# City of Detroit CITY PLANNING COMMISSION

**RE:** Request of Mariners' Church of Detroit for PC (Public Center) Special District Review of proposed exterior alterations to 170 East Jefferson Avenue – Mariners' Church of Detroit

(RECOMMEND APPROVAL WITH CONDITIONS)

# MASTER PLAN

22010.00 job number

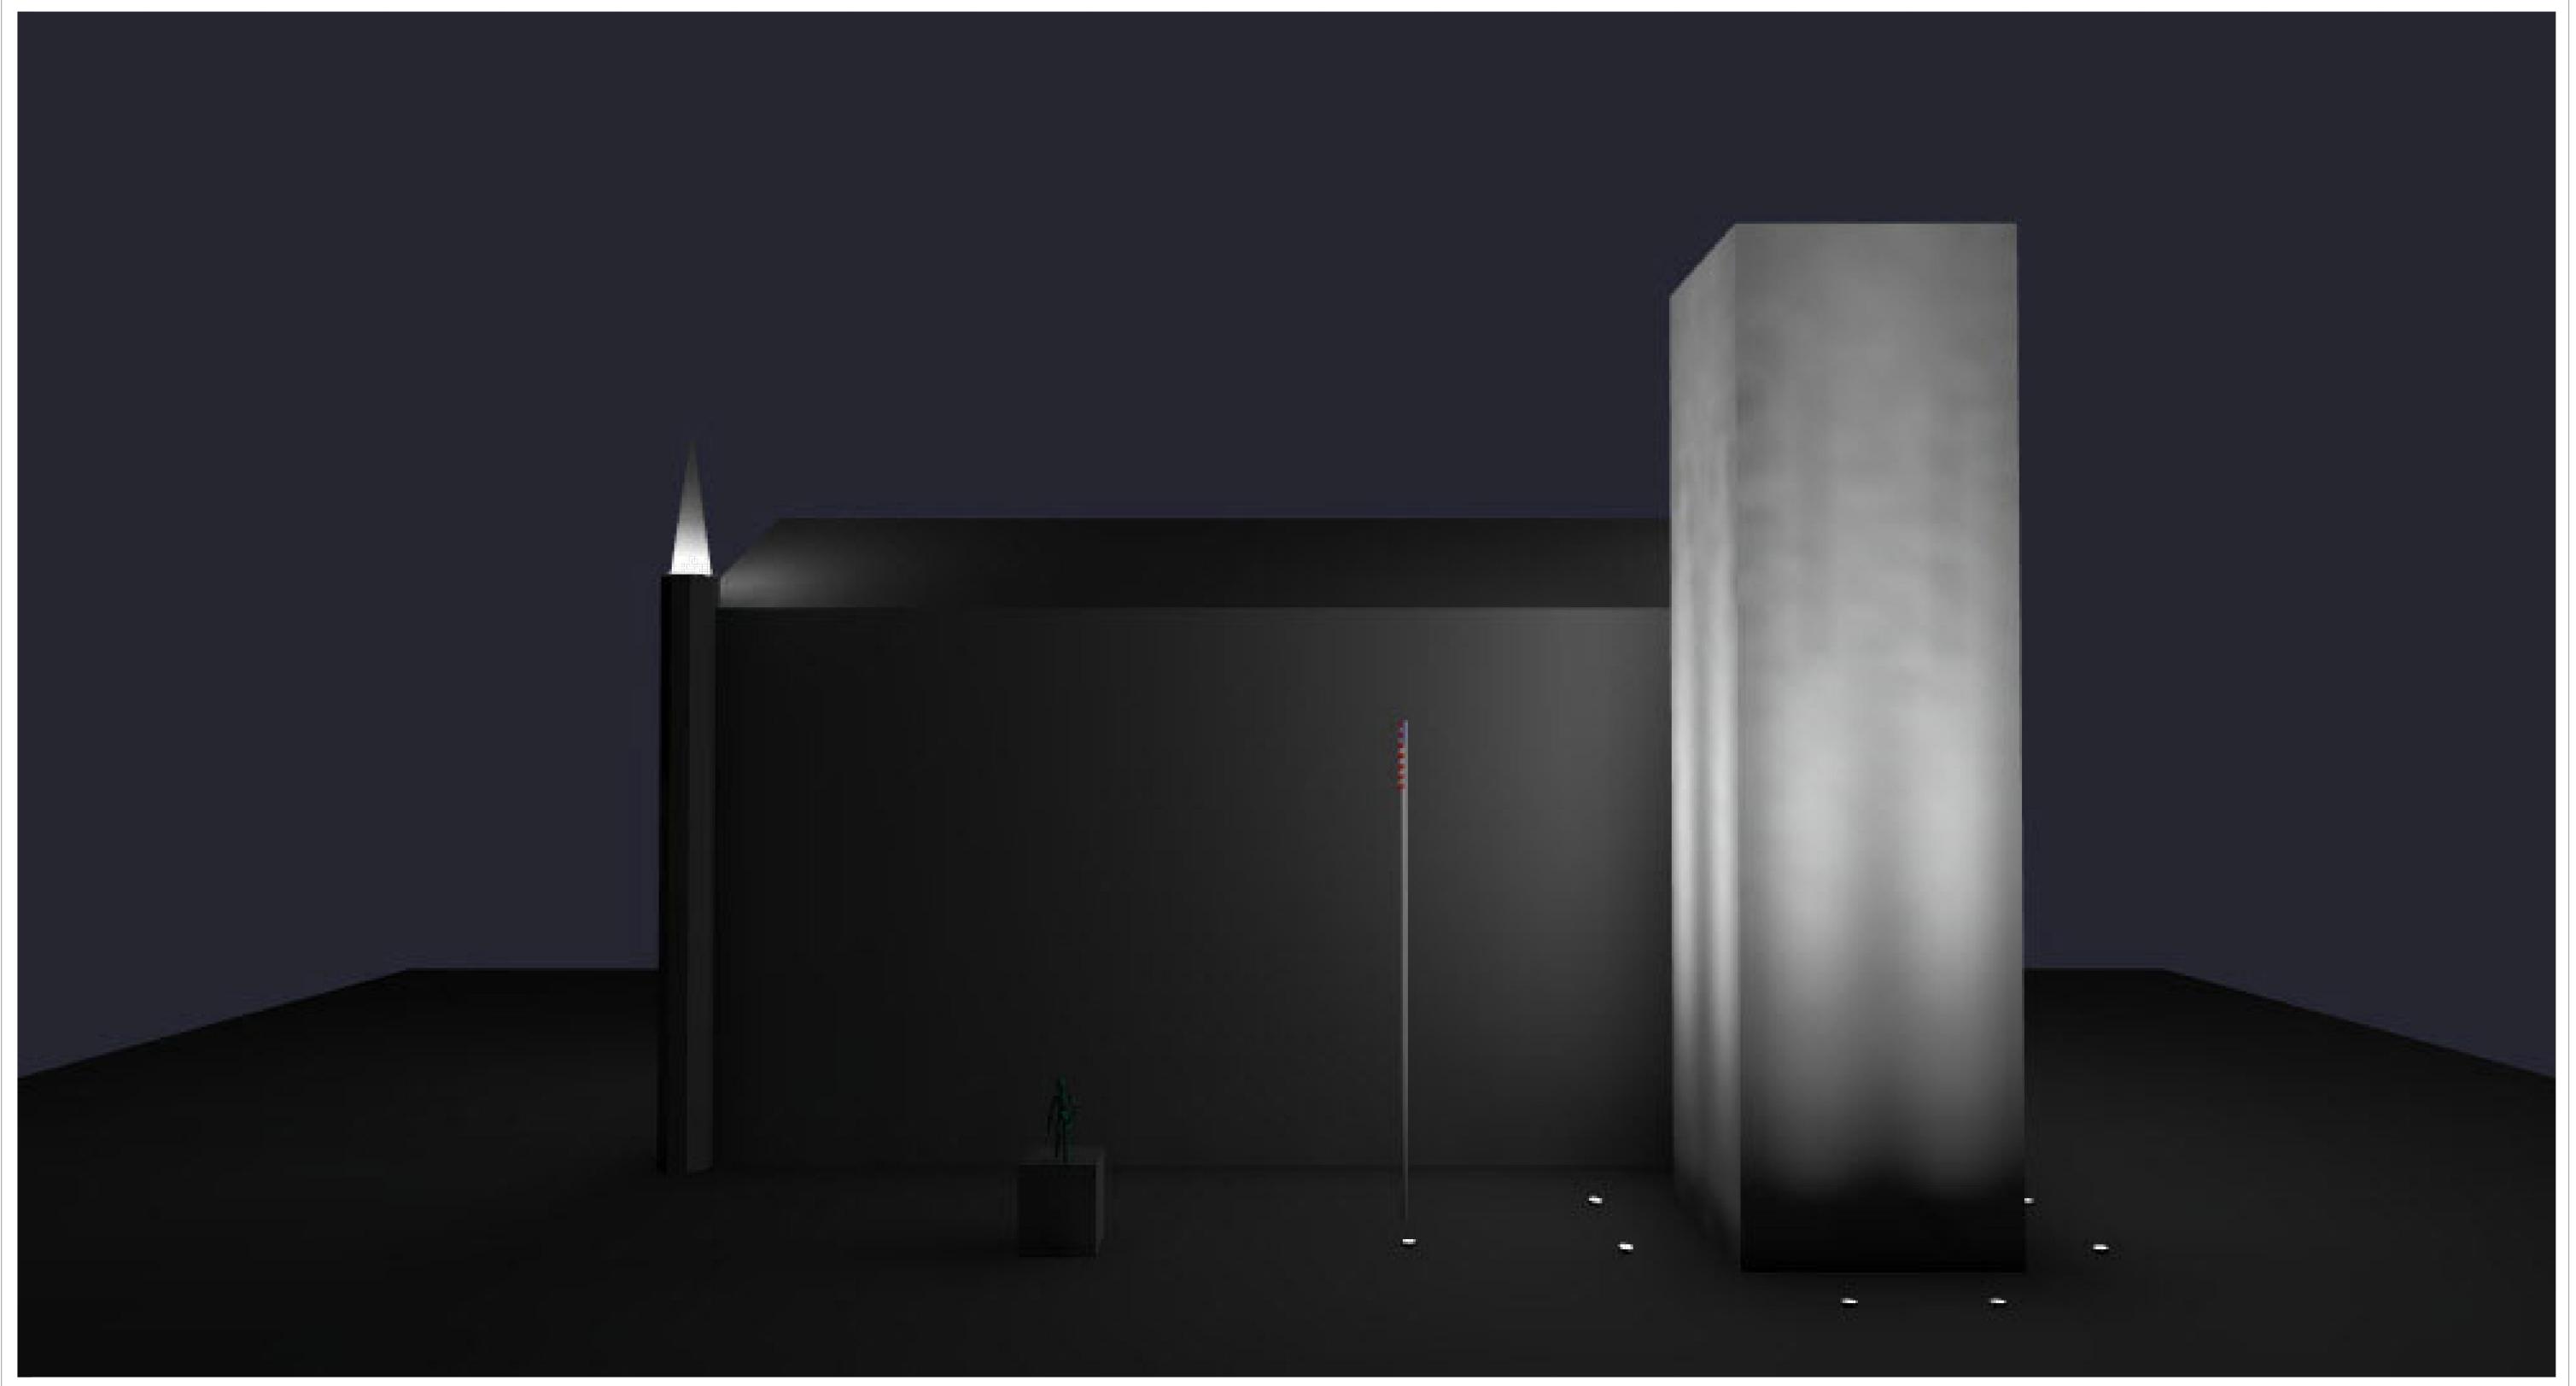
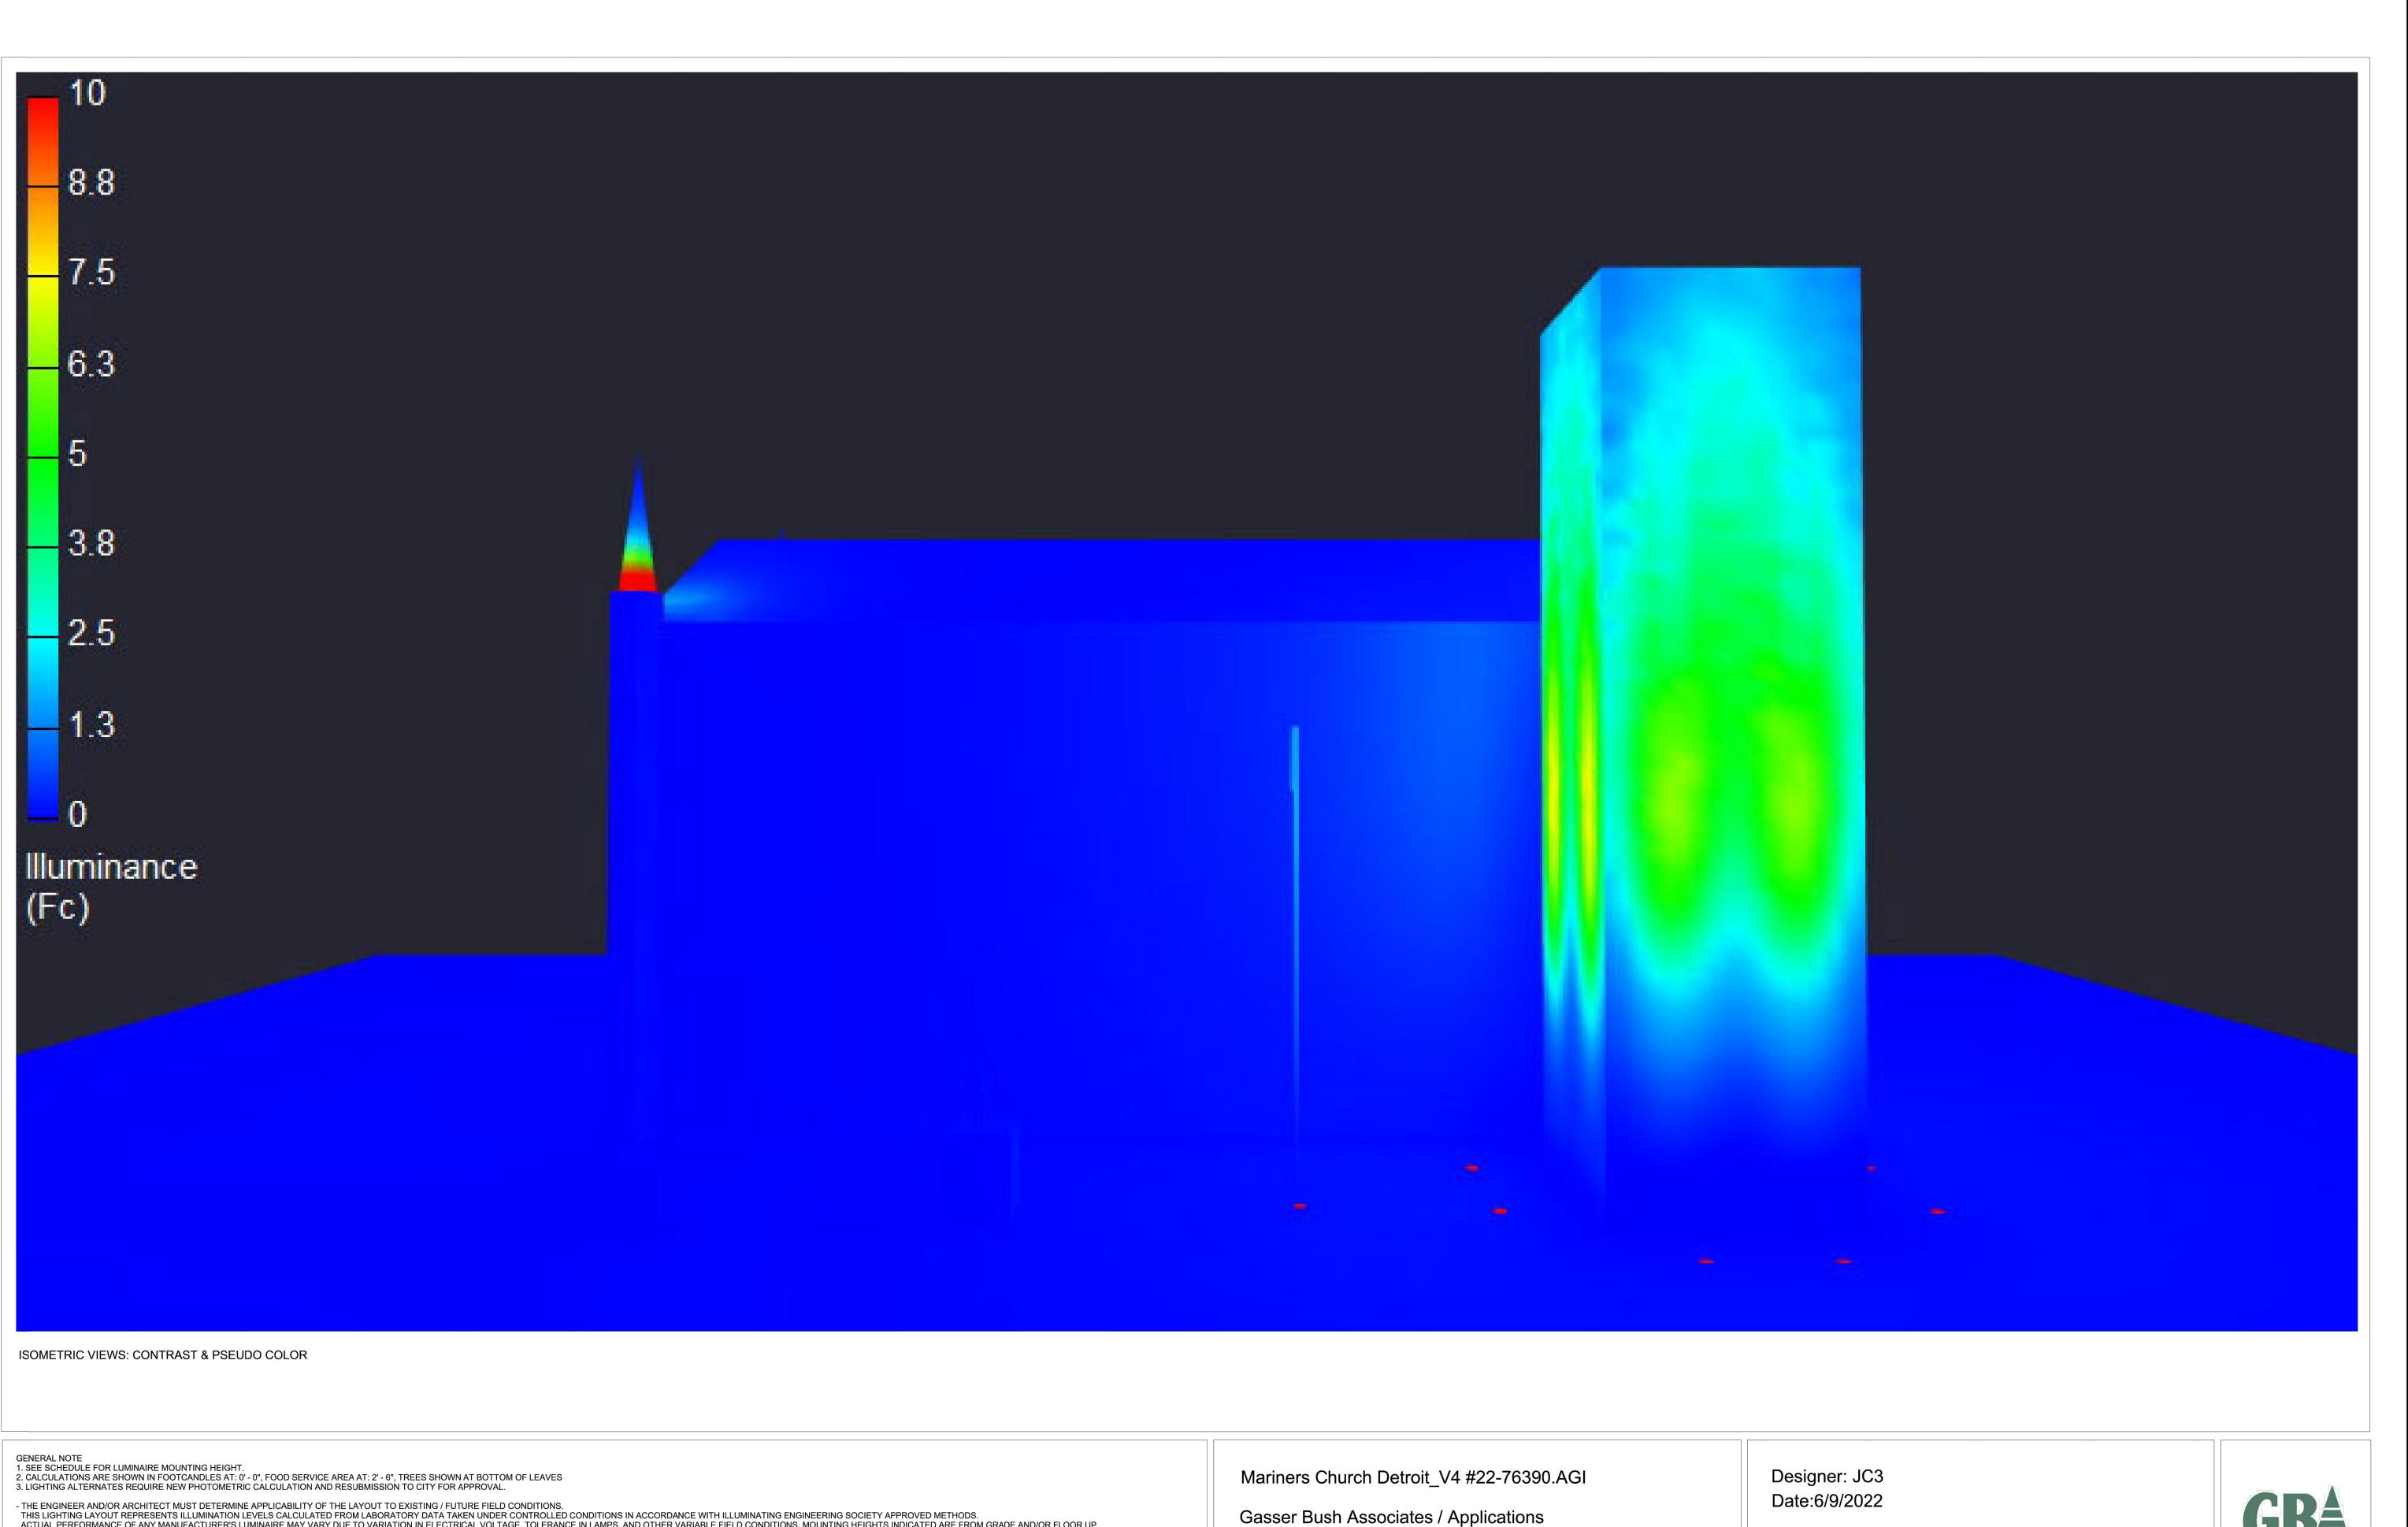
- a. Section 50-14-418 states that all reasonable measures shall be taken to ensure that off-site spillover of light and nightglow are minimized to the greatest extent possible.

- b. CPC staff finds that the revised Site Lighting plan dated July 28, 2022, would take reasonable measures to limit light spillover and nightglow as illuminance levels depicted on sheets A106, A108, and A110 indicate that the highest levels of illuminance would be focused on building facades, the tower, and pinnacles, and would not be focused off-site or directly into the sky. Additionally, there are numerous examples of buildings, especially churches, located within the Central Business District that have similar focused up-lighting provided.
